# Environmental Impact Statement

## Accelerator Production of Tritium at the Savannah River Site

**Final  
March 1999**

**TITLE:** Final Environmental Impact Statement: Accelerator Production of Tritium at the Savannah River Site (DOE/EIS-0270)

Figure 3-4. Land forms, topography, and 100-year floodplain of the preferred and alternate sites. The footprint of the modular design variation is superimposed over the baseline APT footprint at each site.

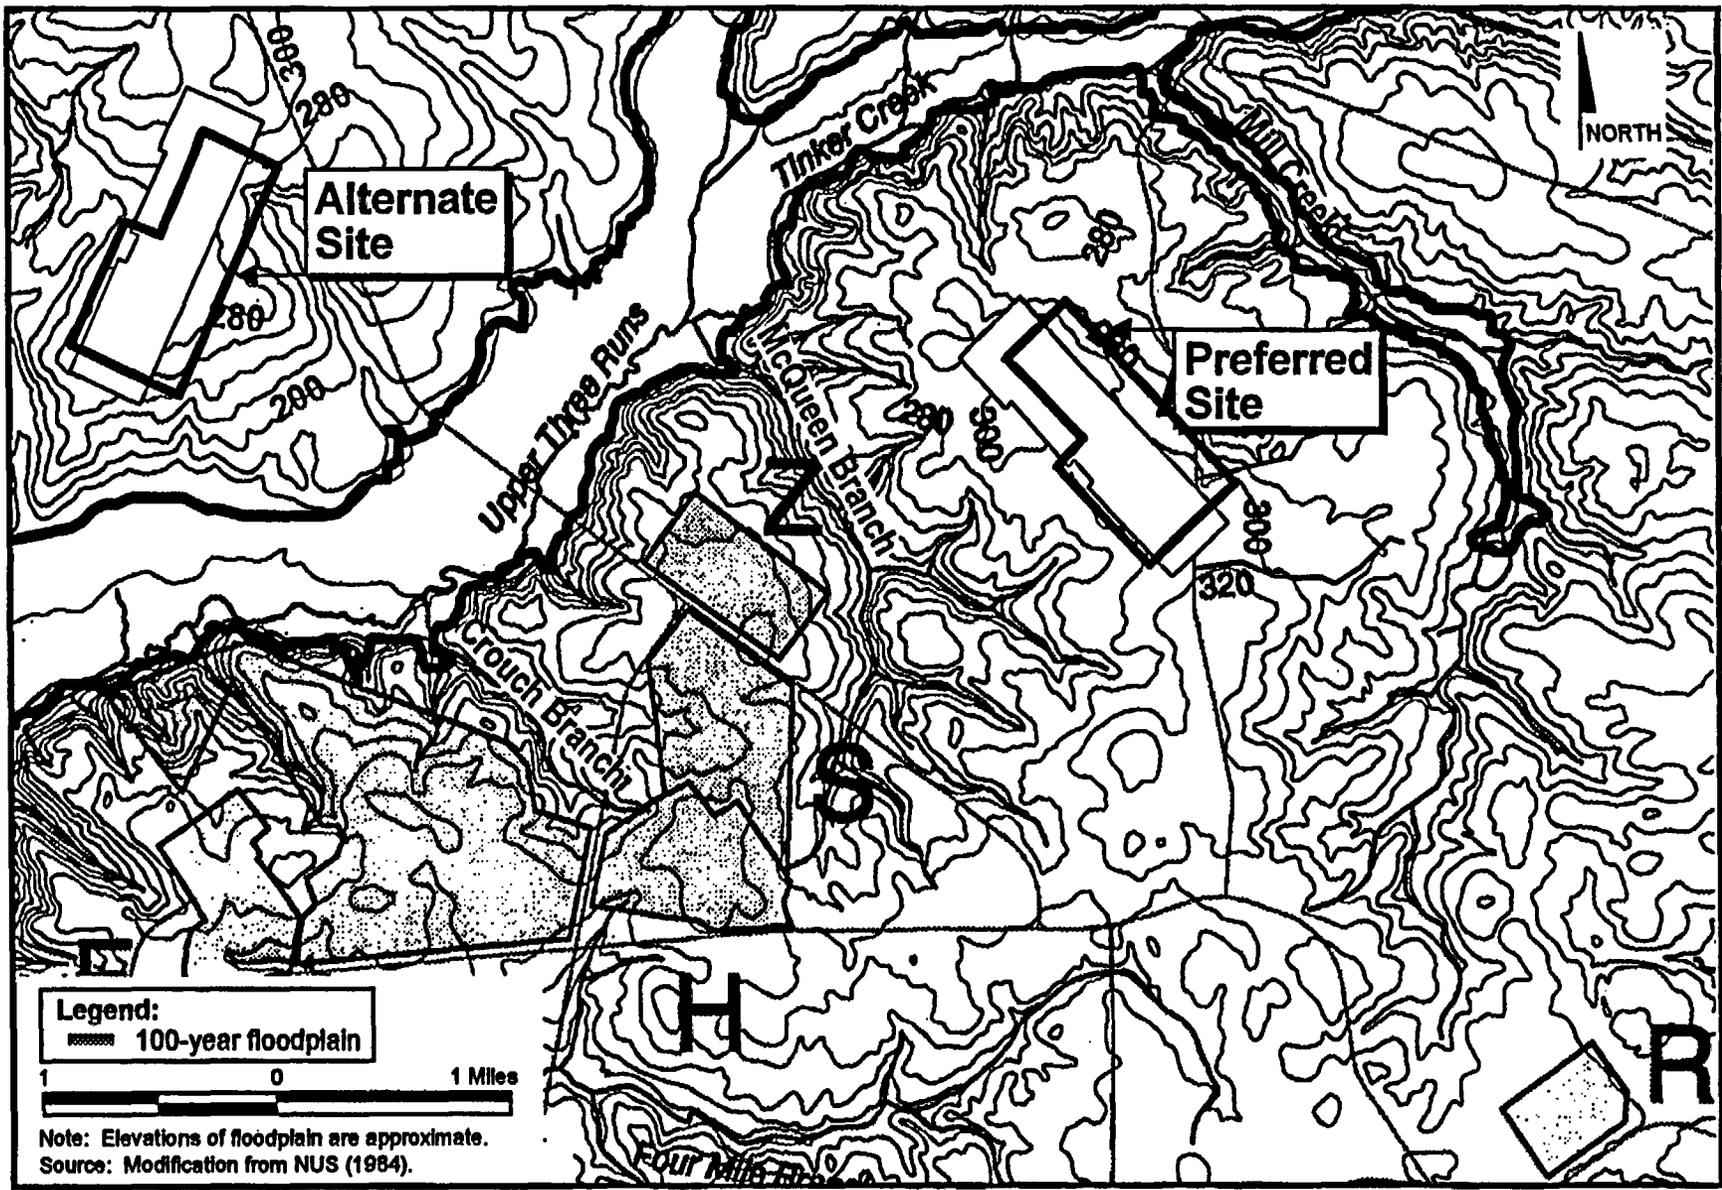
The modular or staged accelerator design variation would result in a small modification of the APT footprint. The overall area would be slightly less than that of the baseline accelerator. Text changes have been made in Section 3.3.1.1, 3.3.1.2, and 3.4.2. Figures 3-4, 3-5, 3-5a, 3-16, and 3-17 and Table 3-1 have been revised to show the modular footprint and its relationship to the footprint for the baseline design.

Page 3-6, 1<sup>st</sup> column, 3<sup>rd</sup> paragraph and Figure 3-4 on page 3-7 are replaced by the following:

Both the preferred and alternate APT sites are on relatively flat, broad and sandy upland areas typical of the Aiken Plateau portion of the Savannah River Site that formed in deep beds of marine sediments (Wike et al. 1994). The orientation of the APT footprint on the preferred site is from southeast to northwest; the footprint orientation on the alternate site from southwest to northeast. Figure 3-4 shows the locations of the sites and their surface features (topography and nearby surface waters). The footprint variation for the modular or staged accelerator design is also shown. As can be seen, the modular design variation would result in a

Figure 3-5. Soil types at the preferred APT site.

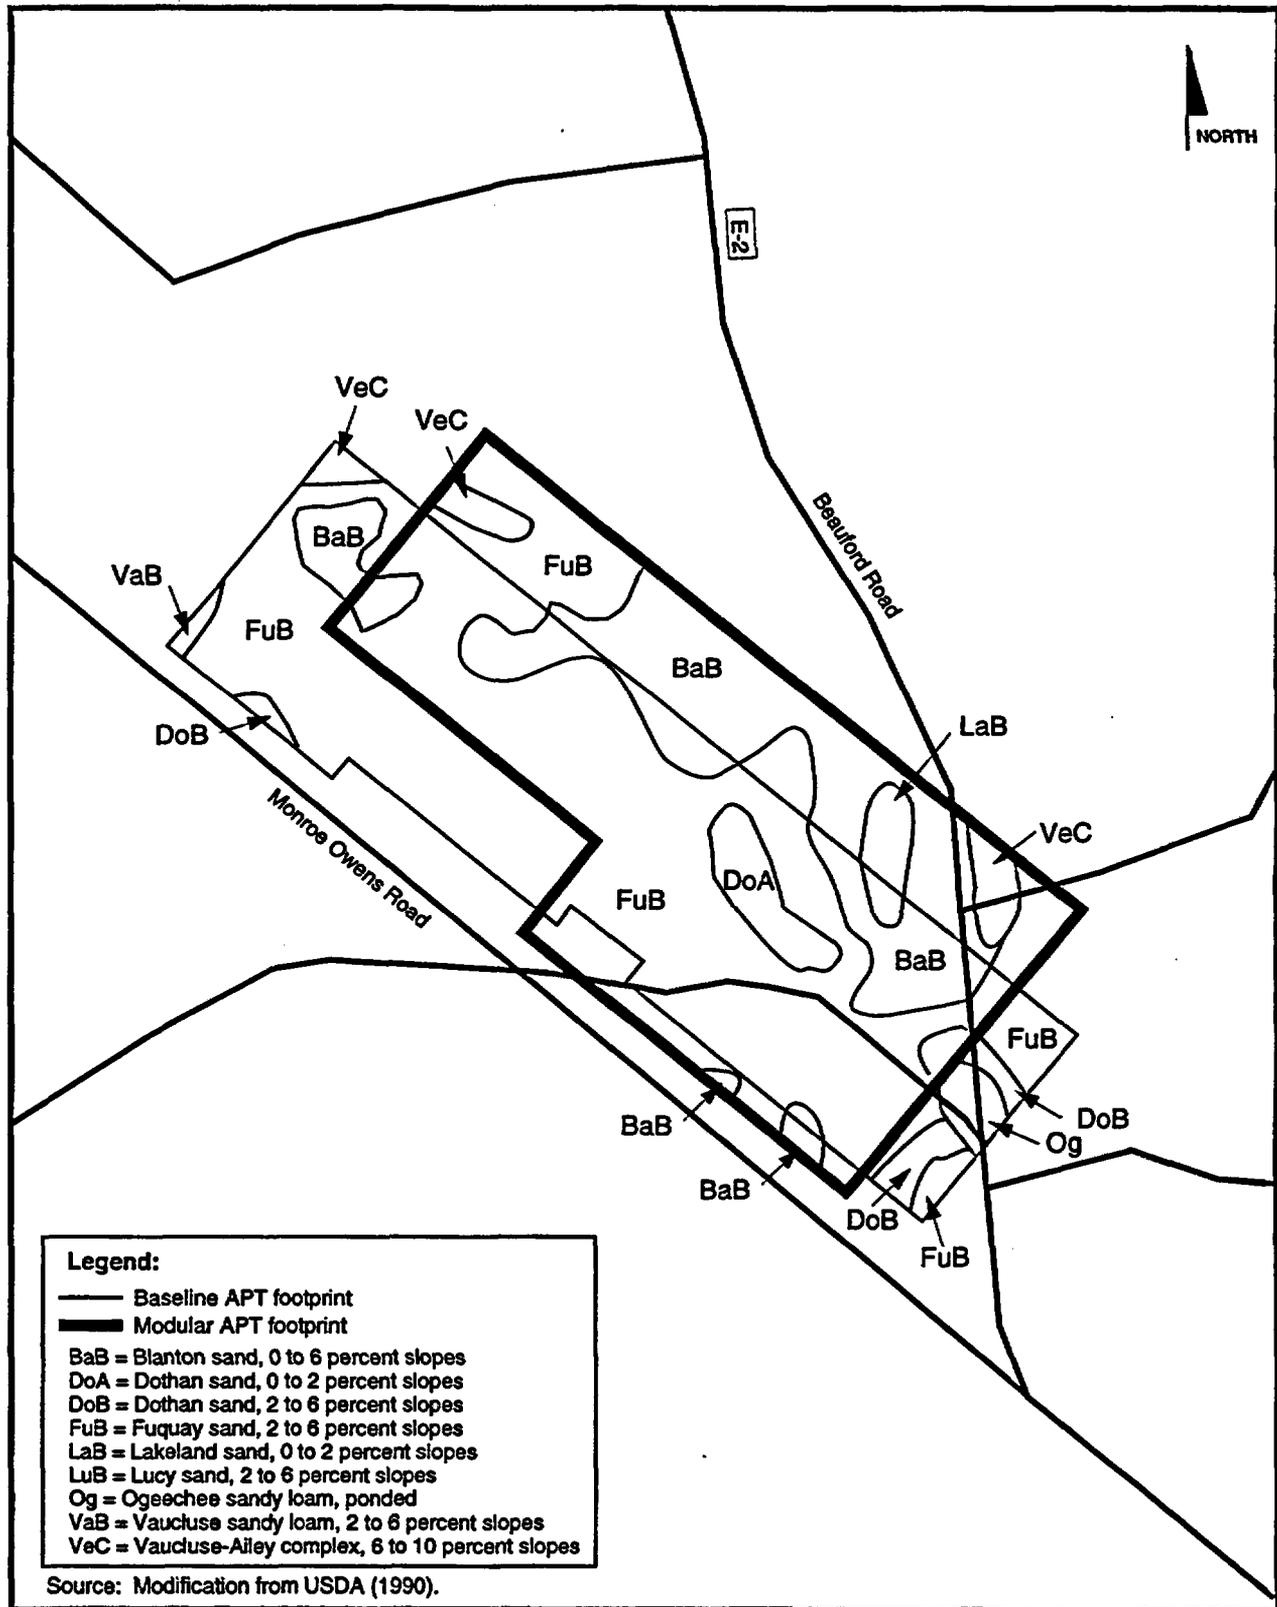
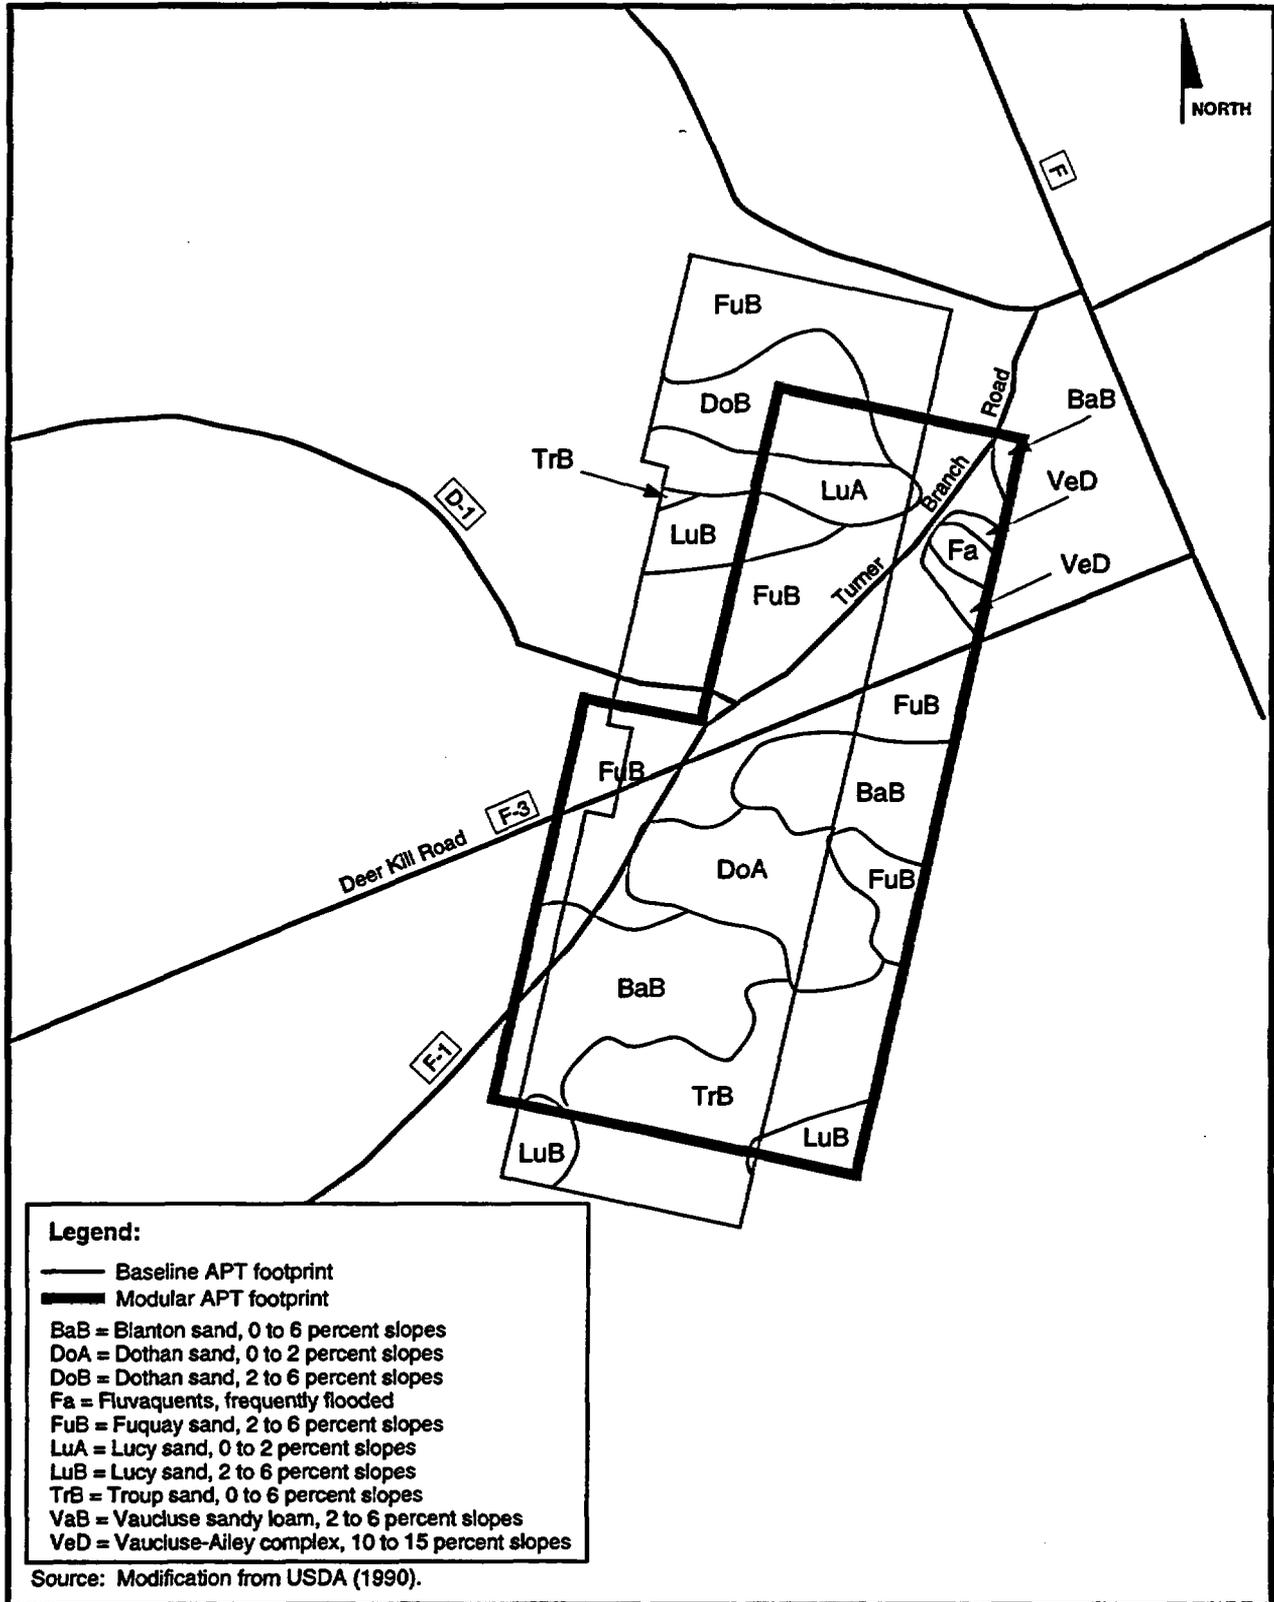
Page 3-8, 1<sup>st</sup> Column, 1<sup>st</sup> paragraph, 5<sup>th</sup> through 9<sup>th</sup> lines, Figure 3-5 on page 3-9, and Table 3-1 on page 3-10 are replaced with the following:

Figure 3-5 and 3-5a, soil maps for the preferred and alternate sites, show the boundaries of the soil mapping units. The footprint variation for the modular or staged accelerator design is also shown. In the case of the modular design footprint, the preferred site would have predominantly Blanton and Fuquay sands.

Figure 3-16. Forest cover of preferred APT site.

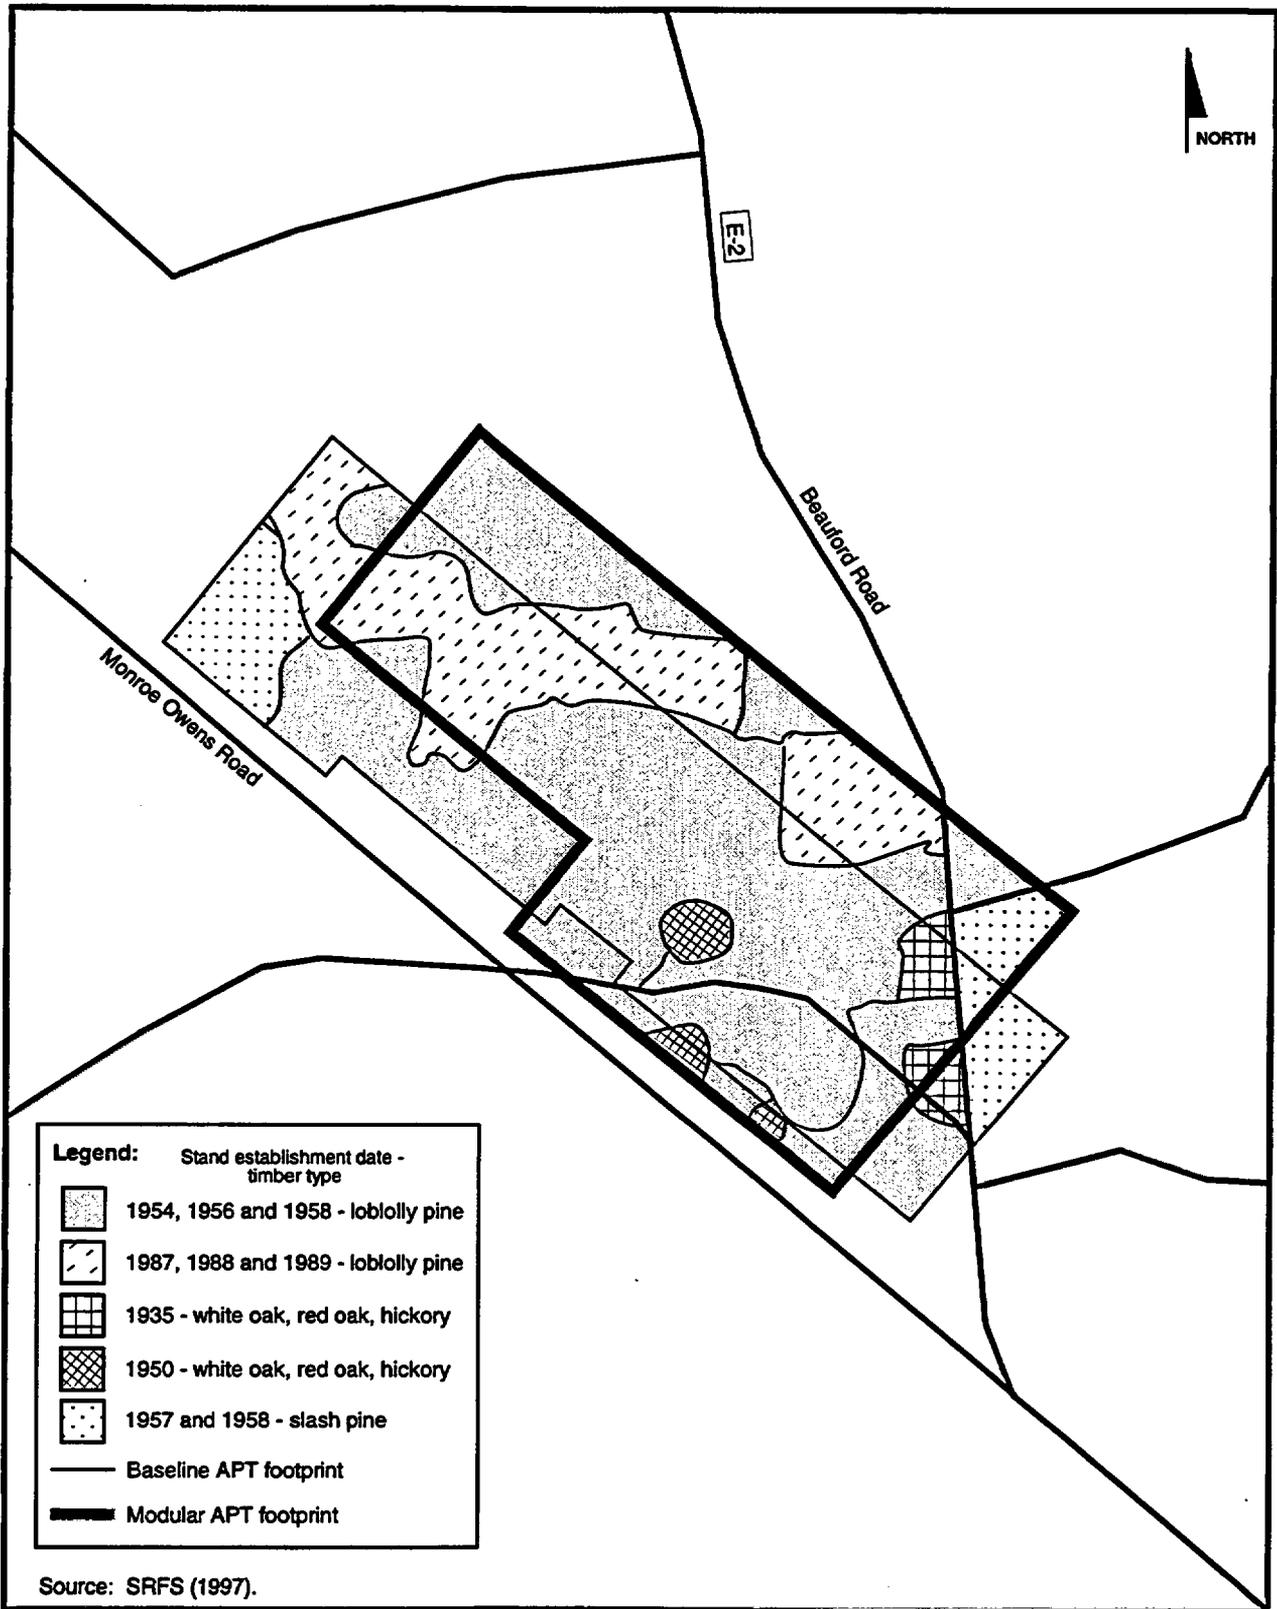
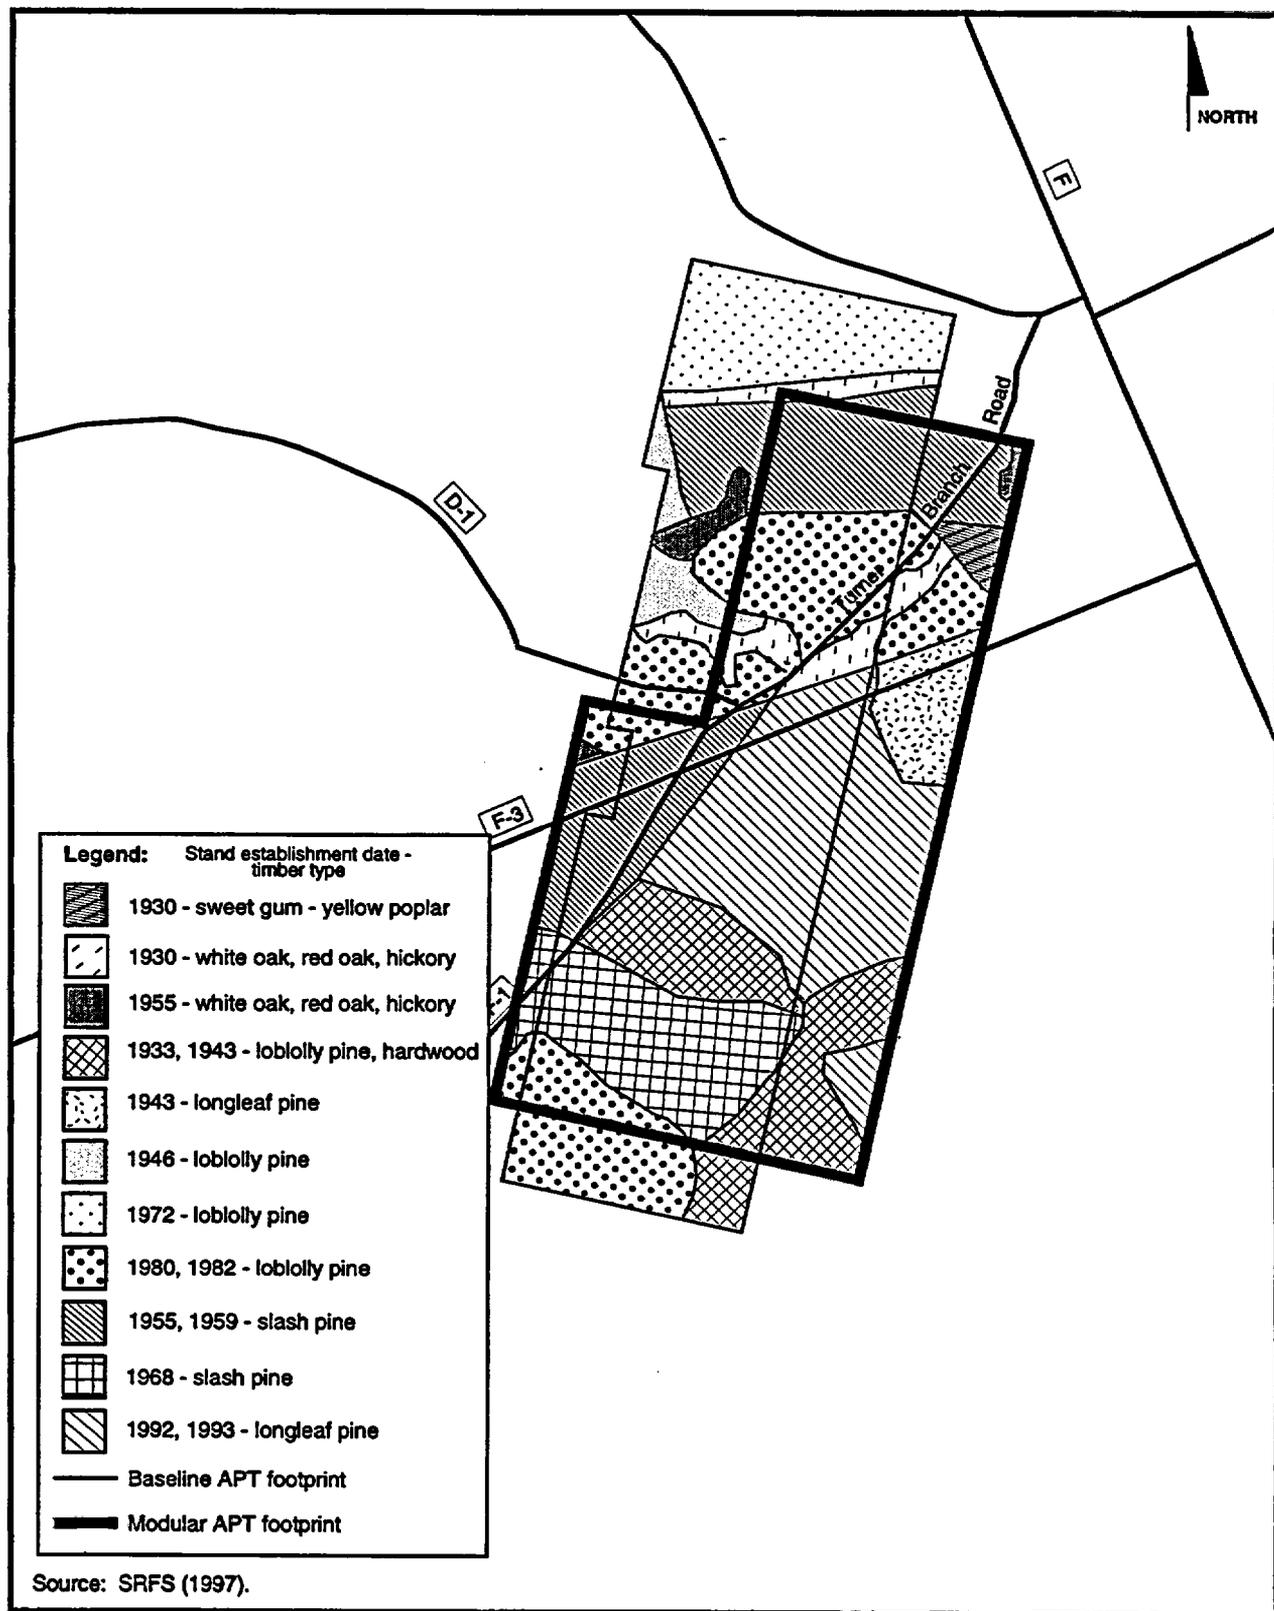
Page 3-44, 1<sup>st</sup> Column, 1<sup>st</sup> paragraph, lines 2 through 15, and Figures 3-16 and 3-17 on pages 3-47 and 3-48 are replaced with the following:

Both sites also have small pockets of 40- and 60-year old upland hardwood stands of white oak, red oak, and hickory ranging in size from 8 to 12 inches in diameter (SRFS 1997). Understory species found on the preferred site include vacciniums (blueberries), sparkleberry, hickories, laurel oak, water oak, southern red oak, sweetgum, black cherry, persimmon, sassafras, and winged sumac. Ground cover includes Japanese honeysuckle, yellow jessamine, greenbrier, muscadine grape, spotted wintergreen, various grasses, legumes, and composites (SRI 1998). Figures 3-16 and 3-17 show the forest cover types of each site. The footprint variation for the modular or staged accelerator design is also shown. In the case of the modular design footprint, forest cover of the preferred site will be virtually the same as with the baseline footprint. On the alternate site, more acres of longleaf pine and mixed loblolly pine hardwood stands will be included in the modular design footprint.
